SILO PROJECT INDEPENDENT REVIEW TEAM DOCUMENTATION - OPERABLE UNIT 4 VITRIFICATION PILOT PLANT FAILURE MODES EVALUATION ANALYSIS

OPERABLE UNIT 4
VITRIFICATION PILOT PLANT
FAILURE MODES EVALUATION ANALYSIS

August 19, 1996

Figure A-1

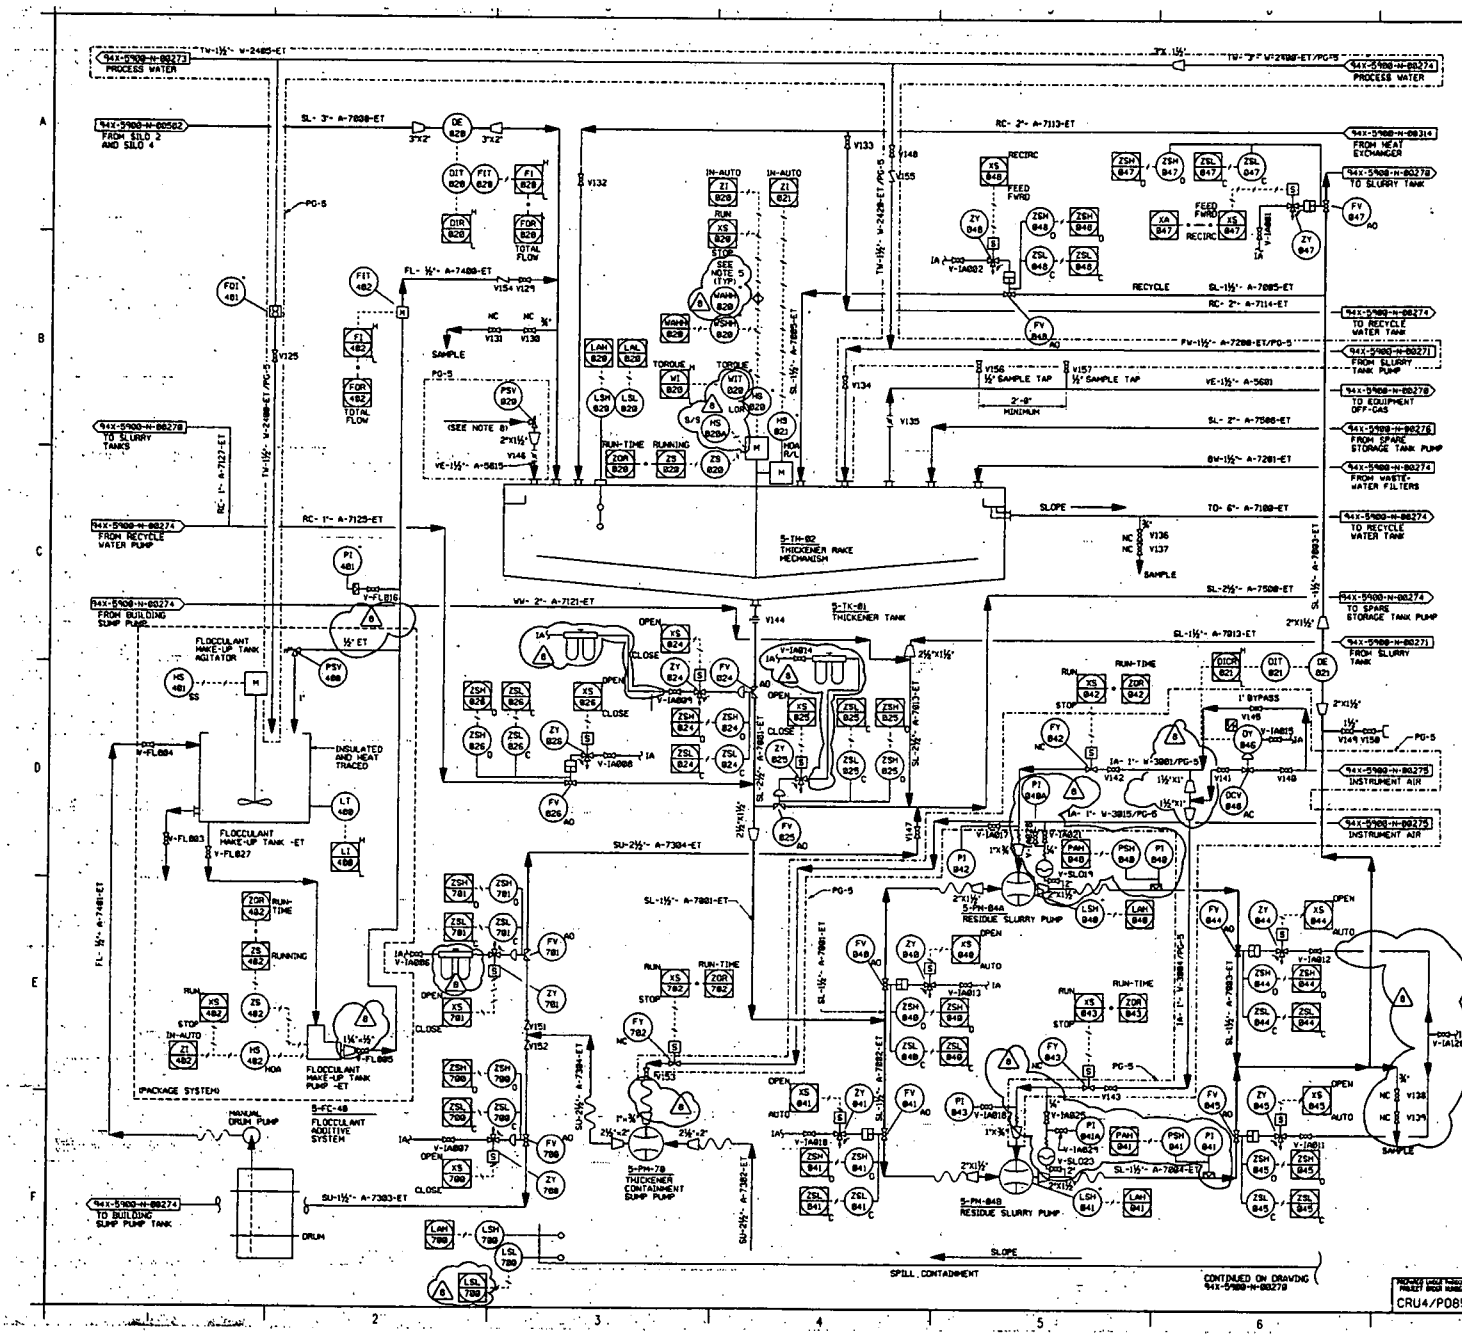
<u>Residue Slurry Pump, PM-04 A/B</u>: Pump failure will cause a no flow condition causing loss of slurry transfer from the Thickener to the Slurry Tanks (a redundant pump is provided). Although a low flow alarm is provided on the feed forward line to the Slurry Tanks (FI-290), it is recommended that a low flow indicator be added to detect loss of flow when the pump is in recycle mode.

Figure A-3

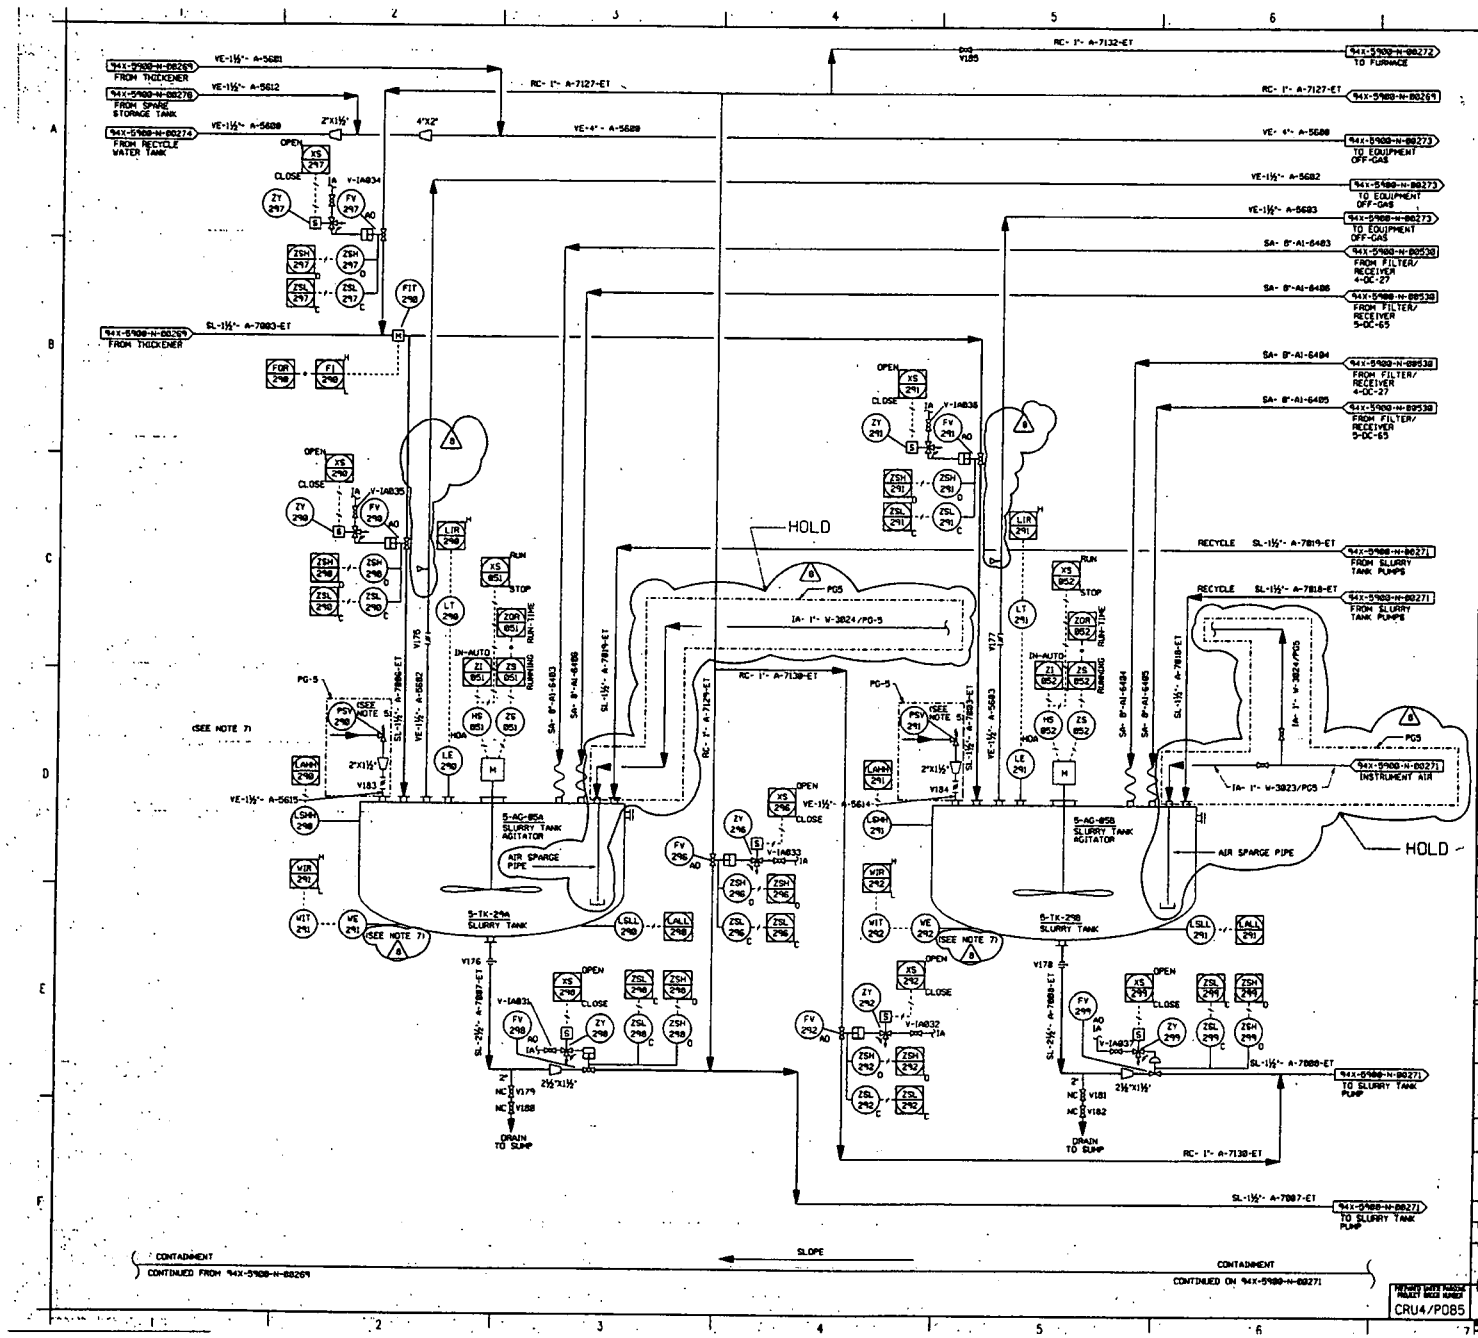
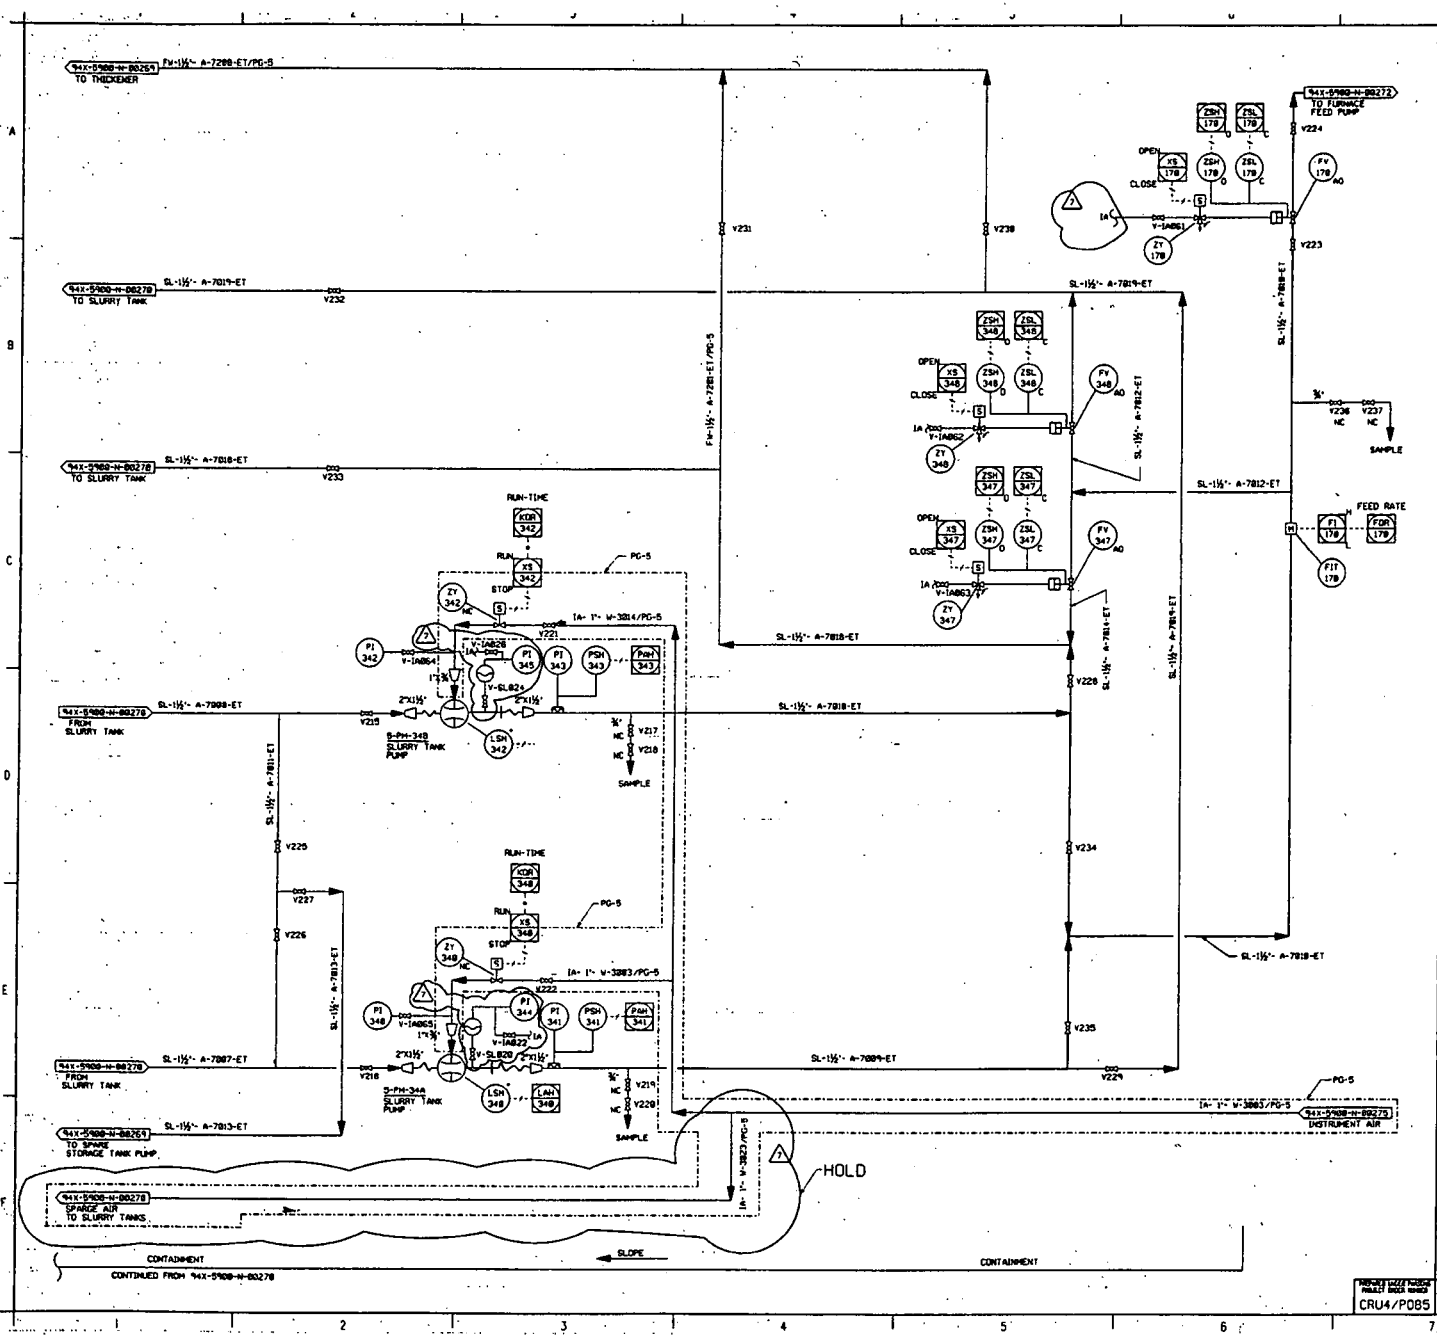
Slurry Tank Agitator, 5-AG-05 A/B: The loss of an agitator component (e.g., motor, gear box, or coupling failure) will cause a failure to provide a properly formulated slurry. It is recommended that operations discontinue melter feed operations upon indication from XS-051/052 (motor failure indicator).

Melter Feed Valve, FV-170: Failure of the melter feed valve to open due to loss of instrument air or valve malfunction will prohibit slurry transfer to the melter feed pump. Although methods exist to detect this condition (e.g., decrease in gem production rate, camera view of melter cold cap), these methods do not provide immediate detection

for operator response. It is recommended to provide a low melter feed rate alarm in the control room to allow operators to better respond to this upset condition.

Figure A-15

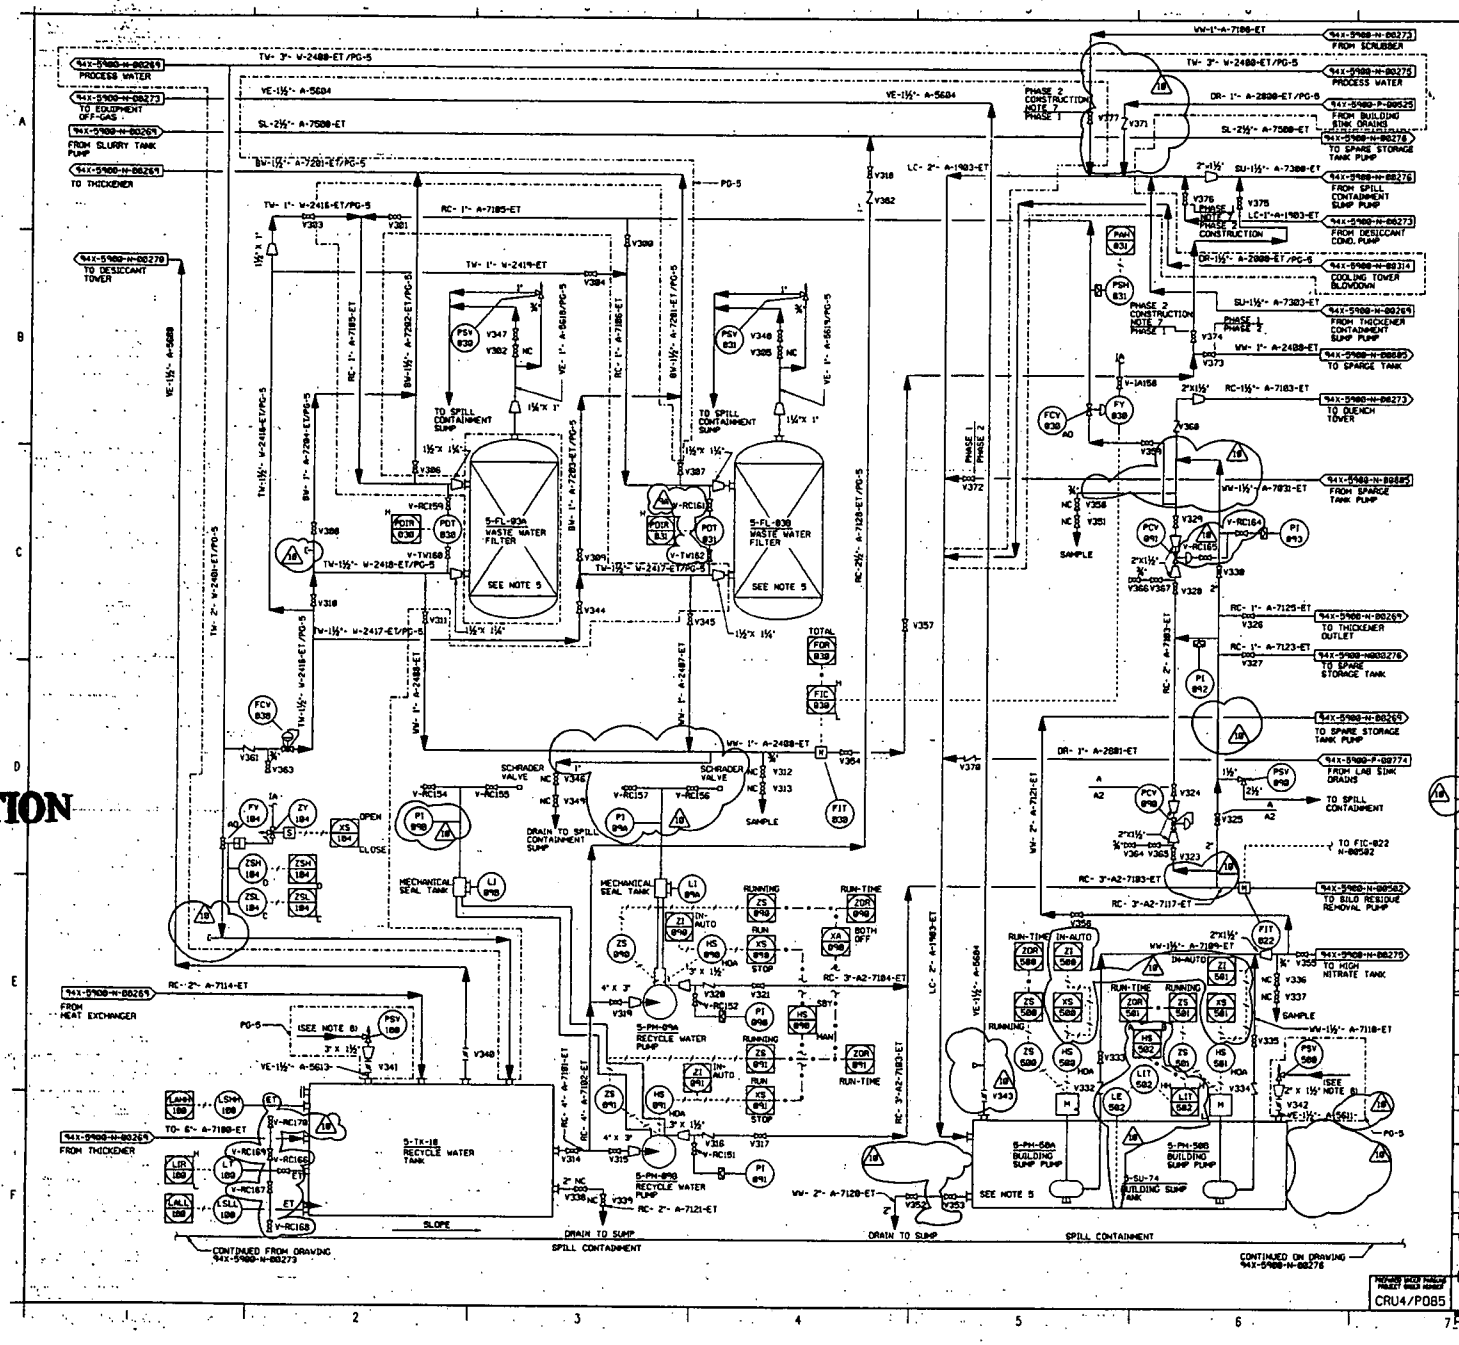
Recycle Tank Vent Damper, V-340: Failure of this component in the closed position due to an operator error will result in the inability to vent the Recycle Tank to the off-gas line. Currently no method of detection exists for this condition, therefore, it is recommended that a local pressure indicator be provided on the Recycle Tank to indicate a closed/blocked vent valve condition (a study of tank vent routing and venting is to be performed before VITPP Phase II. This concern and comment is generic for all tank vents).

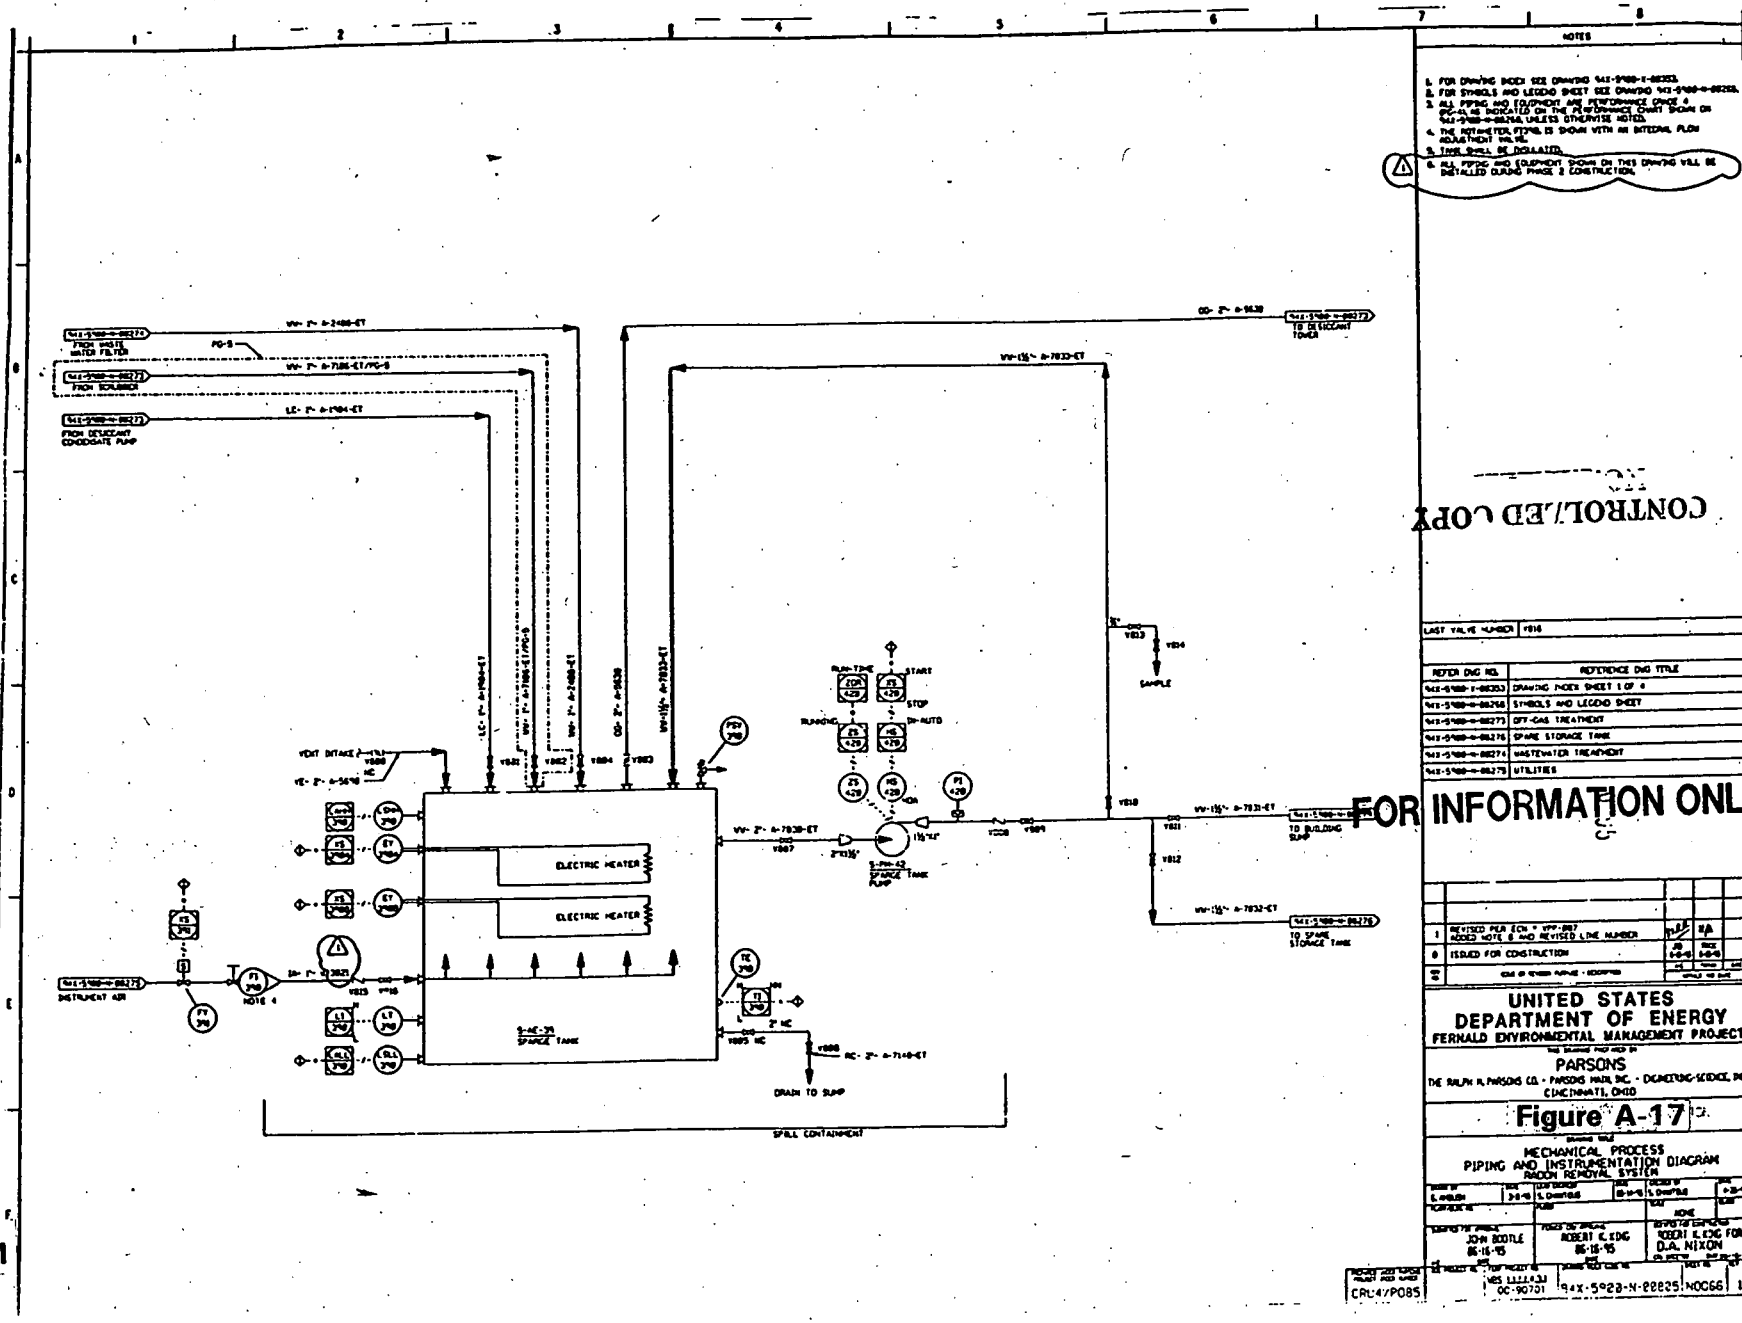
Sparge Pump, 5-PM-42: A power outage will cause a loss of flow condition from the Sparge Tank (5-AE-39) to the building sump (PI-428 will indicate this condition). As the plant becomes reactivated (stand-by power), several systems will re-establish water flow to the Sparge Tank (flows from the off-gas desiccant tower, the off-gas scrubber, and the waste water filters). Over an extended outage, this water will accumulate in the Sparge Tank. It is recommended that connecting the Sparge Pump to stand-by power for plant restart during extended outages be considered.

Electrical Heaters: A power outage will cause a loss of heating capacity by the in-tank, submerged heating elements for radon removal. As the plant becomes reactivated (stand-by power), several systems will re-establish water flow to the Sparge Tank (flows from the off-gas desiccant tower, the off-gas scrubber, and the waste water filters). Over an extended outage, this water will accumulate in the Sparge Tank. It is recommended that the electrical heaters be connected to stand-by power for plant restart/radon removal operations during extended outages be considered.

Solenoid Valve, FY-391: Failure of this solenoid valve to activate upon demand due to malfunction or inadvertent closure will result in a loss of sparge air flow condition. Consequently, water leaving the plant is high in radon content. It is recommended that a manual bypass to FY-391 be considered.
